TASKI TCS Information

Squeegees for Combimates and Swingo

New bumper wheels

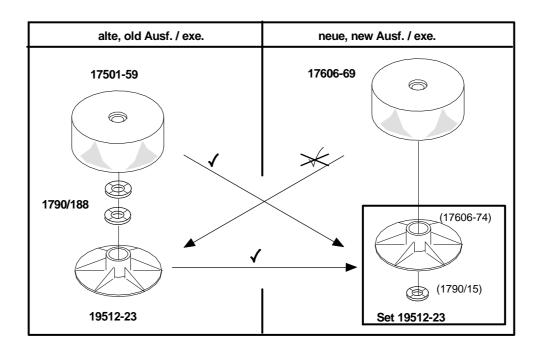
The bumper wheels on the most of our squeegees will be replaced by a new wheel soon. This modification is necessary for the new Swingo line (750/1250), because they get a new weight built in; please refer to the corresponding spare parts catalogue.

The following version has to be compared:

- Please check the compatibility according to the arrows in the drawing.
- The sustaining disc (19512-23) in the old version is not available anymore. You will get automatically the Set 19512-23 (containing new sustaining disc (17606-74) and waved washer (1790/15) according to drawing on the right side).
- The two waved washers (1790/88) are not anymore required in the new composition, these is also not necessary for the combination 17501-59 with Set 19512-23.
